**Meridian Airport Authority, Dean Aircraft Services
Hangar Additions & Alterations**

ADDENDUM NO. 4

TO: All Bidders on the Above Referenced Product
FROM: Davis Purdy Architects, PLLC
DATE: April 5, 2021
SUBJECT: **ADDENDUM NO. 4**

A-800

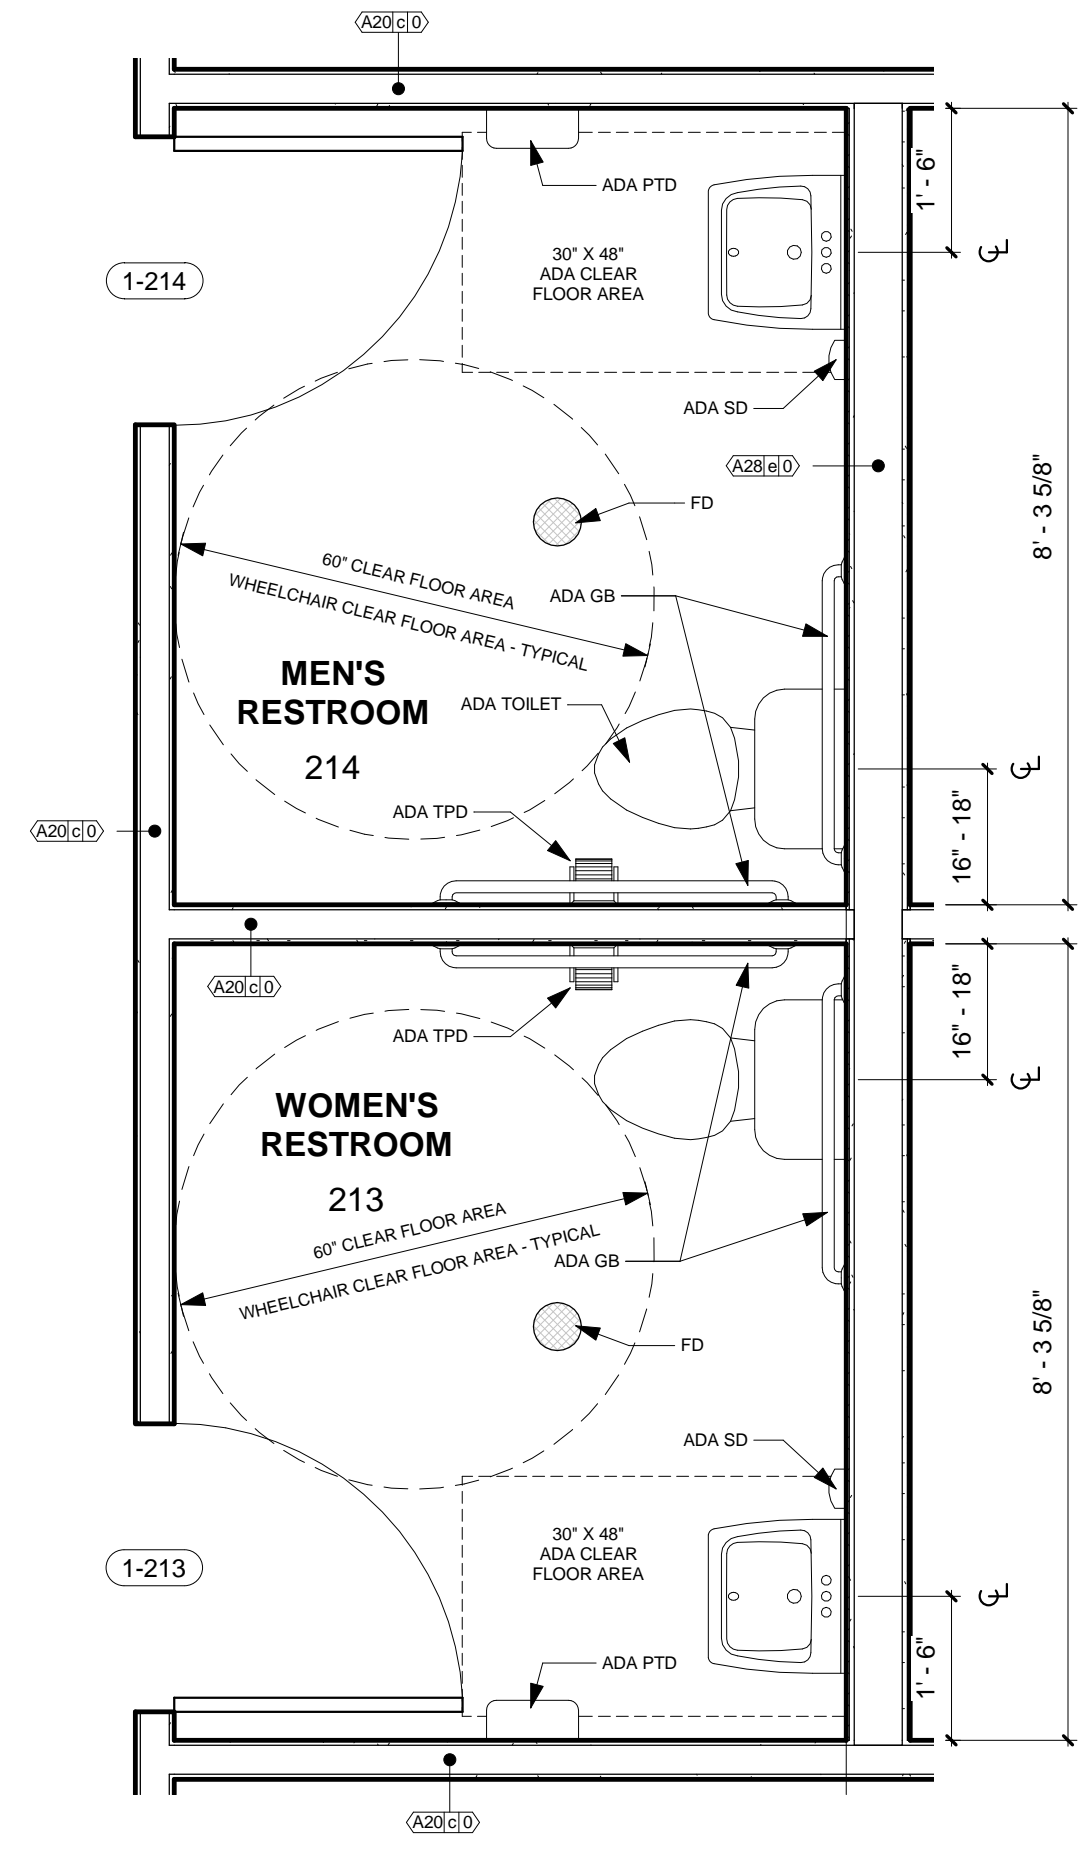
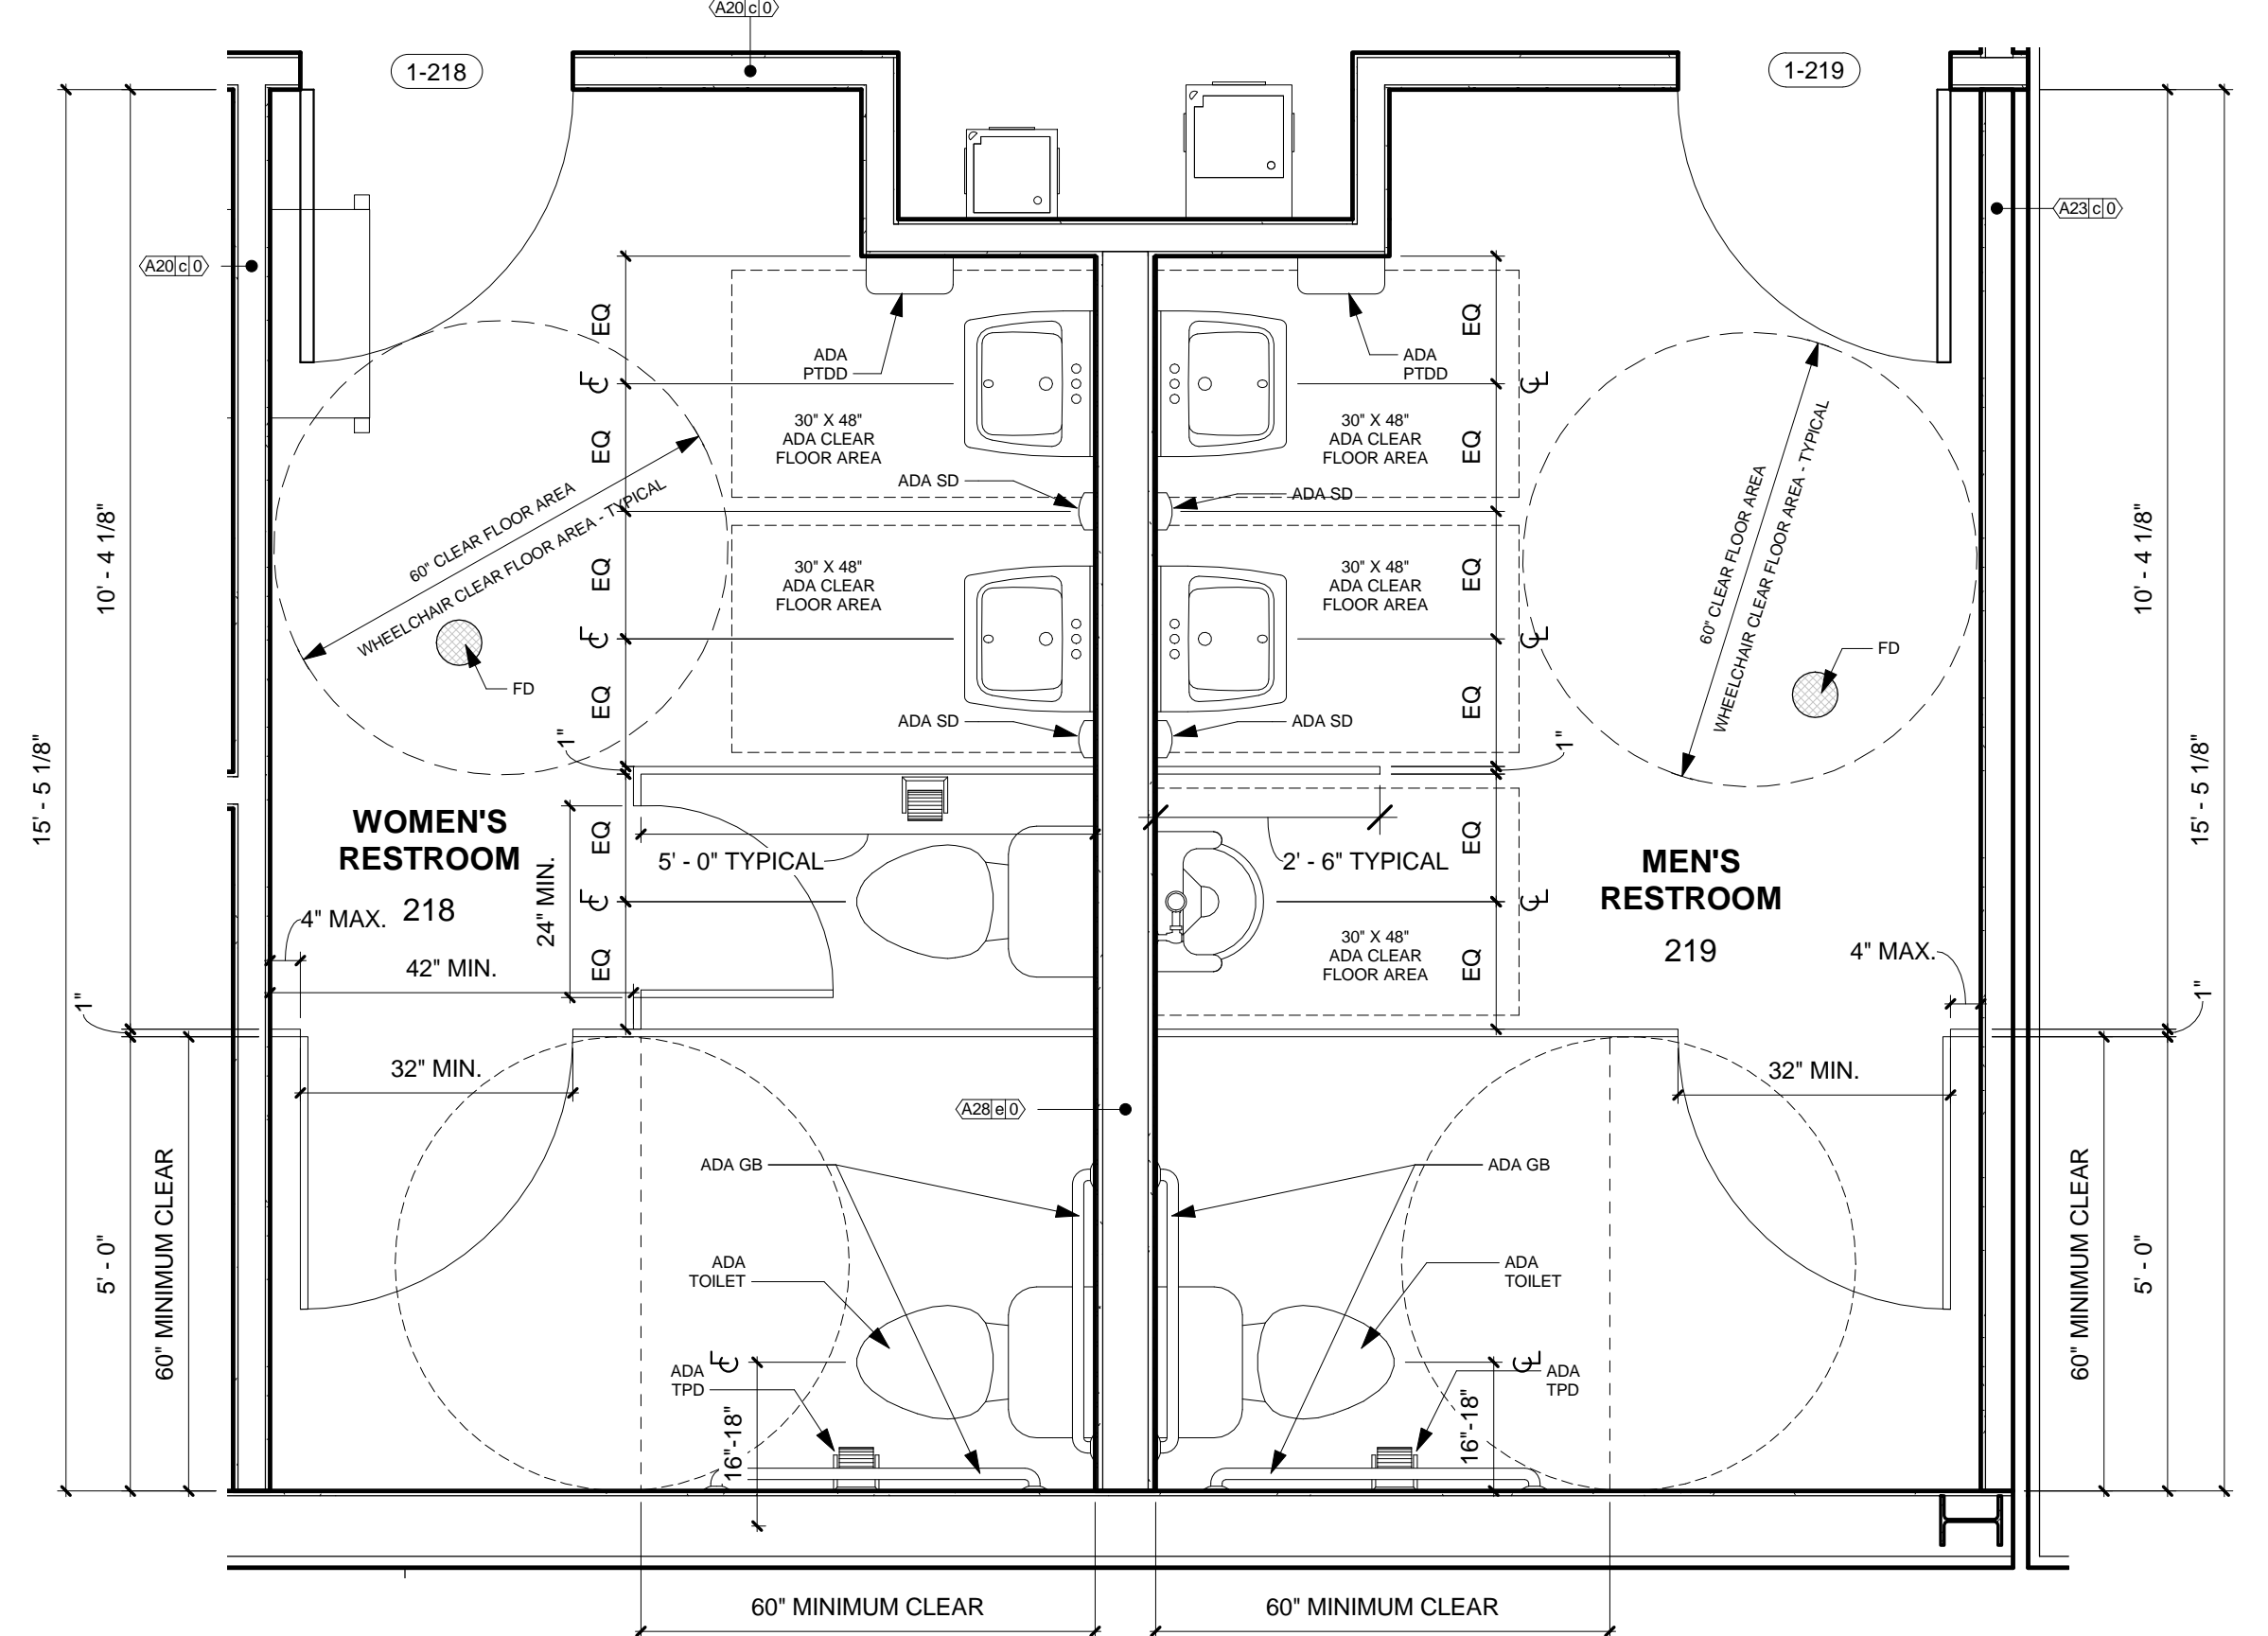
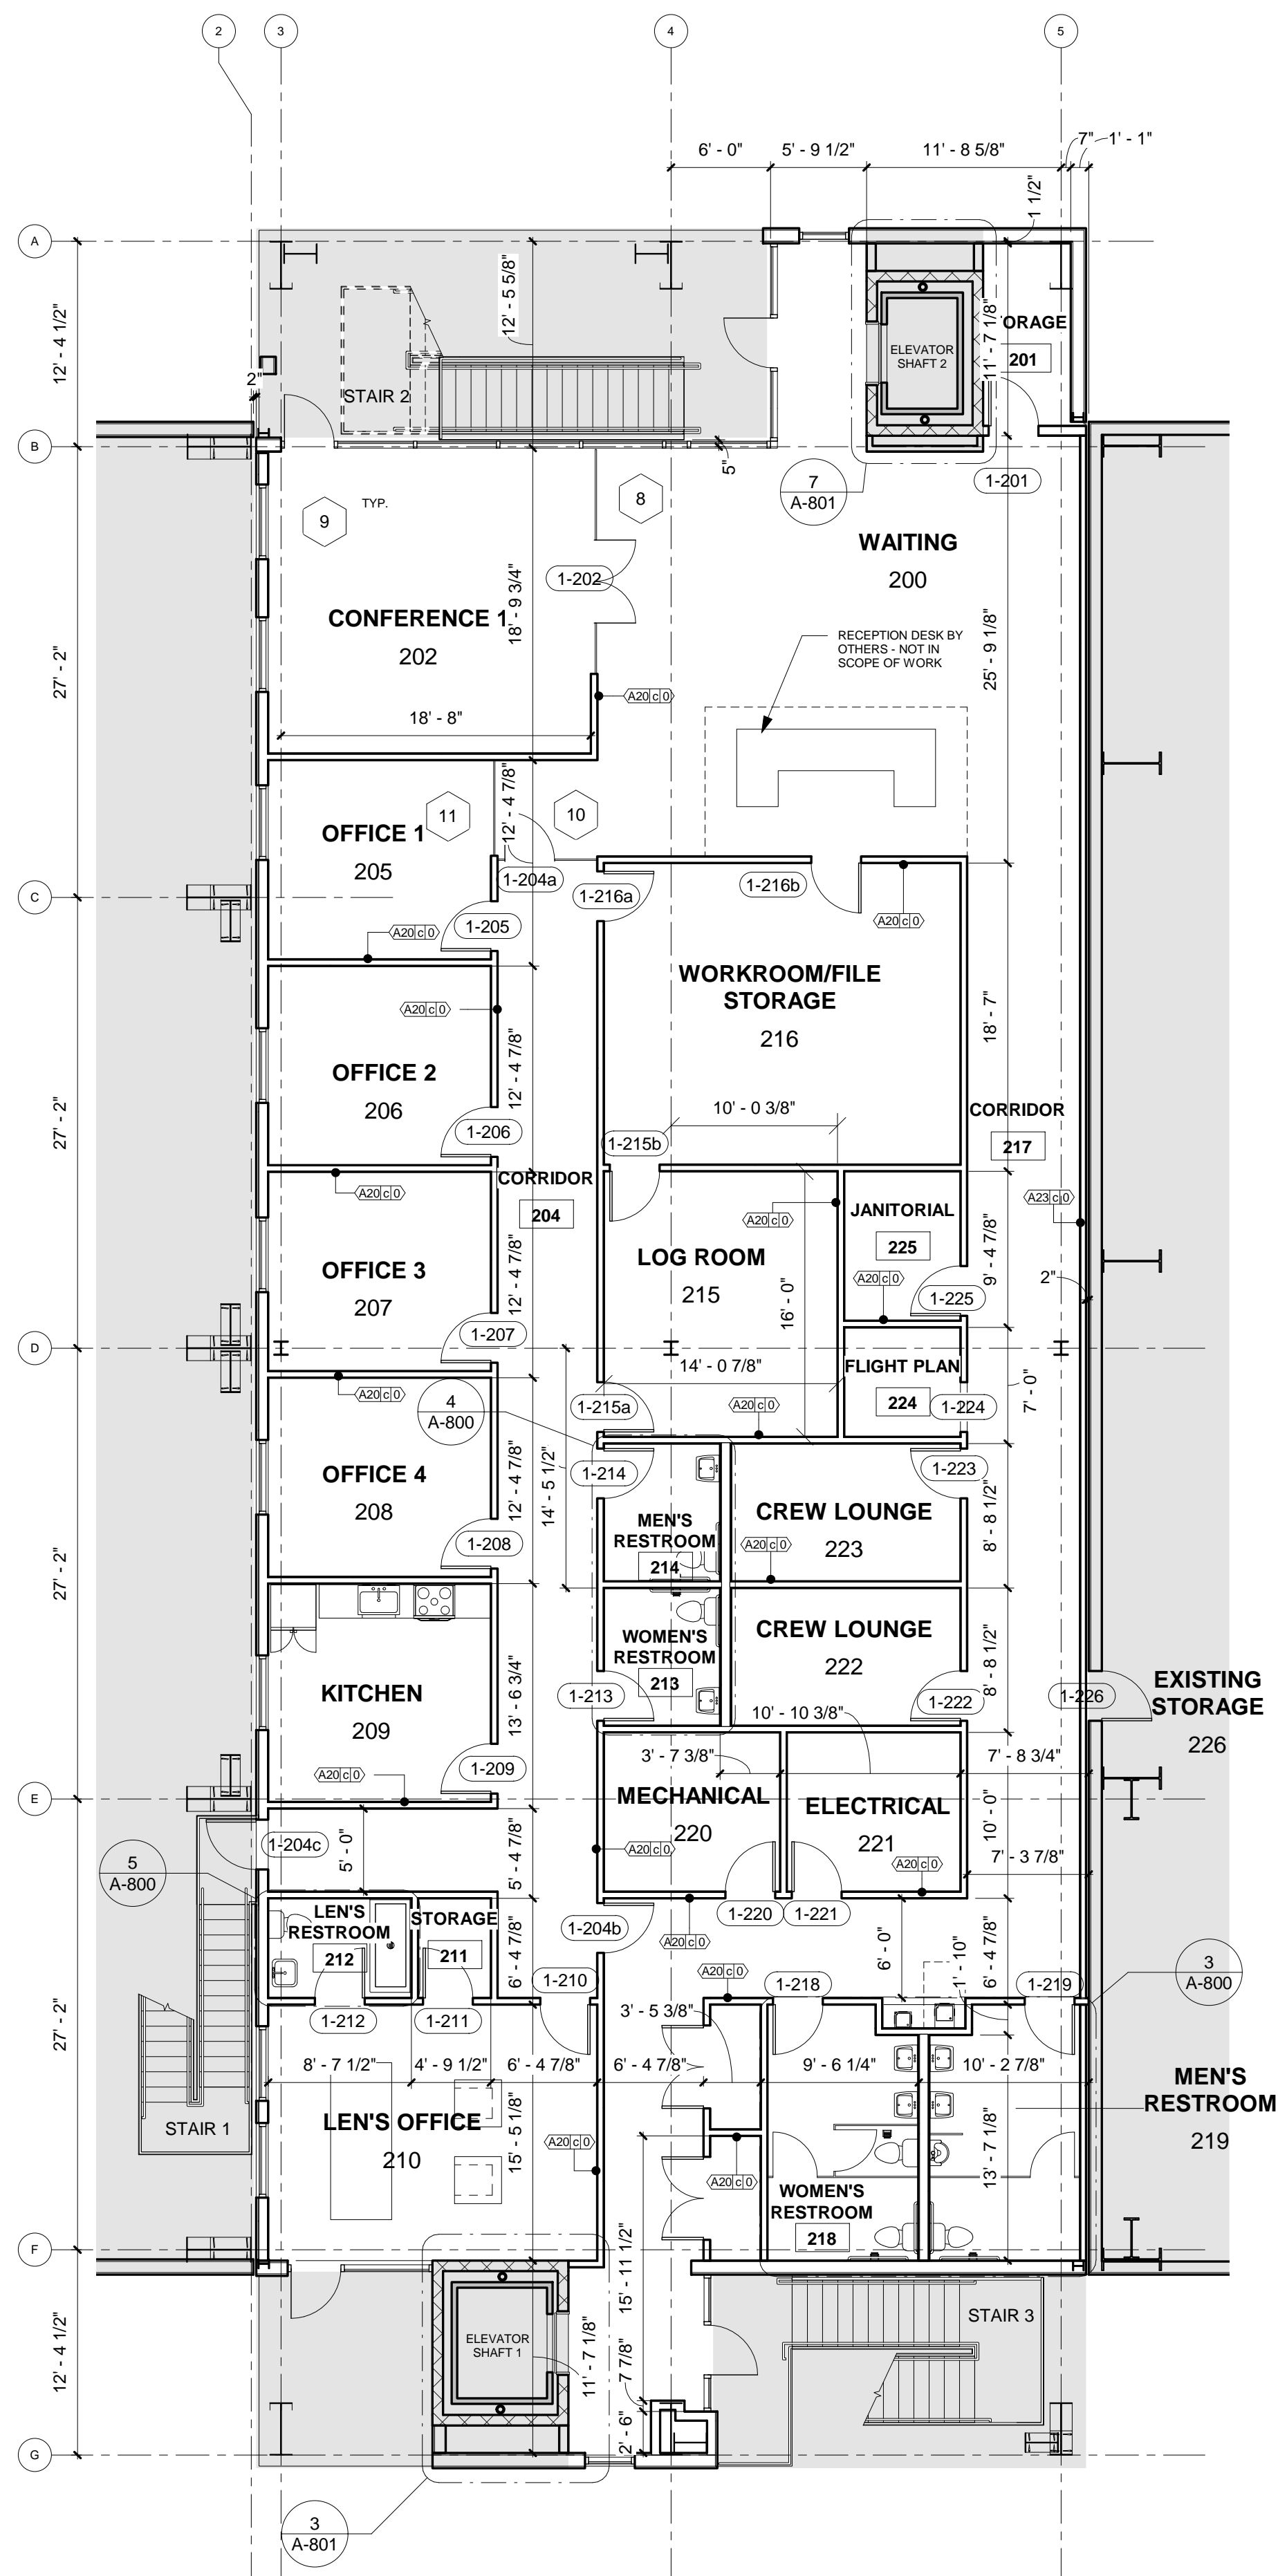
9. **REPLACE:** Replace Architectural sheet **A-800** dated 3/3/21 with the same sheets dated 4/5/21. Minor changes are indicated with clouds on sheets along with a written narrative (Dean Hangar – Addendum #4 Narrative). Architectural sheet A-800 is attached.

10. **CLARIFICATION:** Partition types shown on Architectural sheet A-800 shall extend 12” minimum above ceiling. Contractor shall provide bracing as required to stabilize partitions.

11. **CLARIFICATION:** Architectural sheets A-602 and A-800 indicate toilet rooms receiving tile walls. Provide tile on fixture walls only extending from floor to ceiling.

WALL TAGS HAVE BEEN ADDED TO PLANS
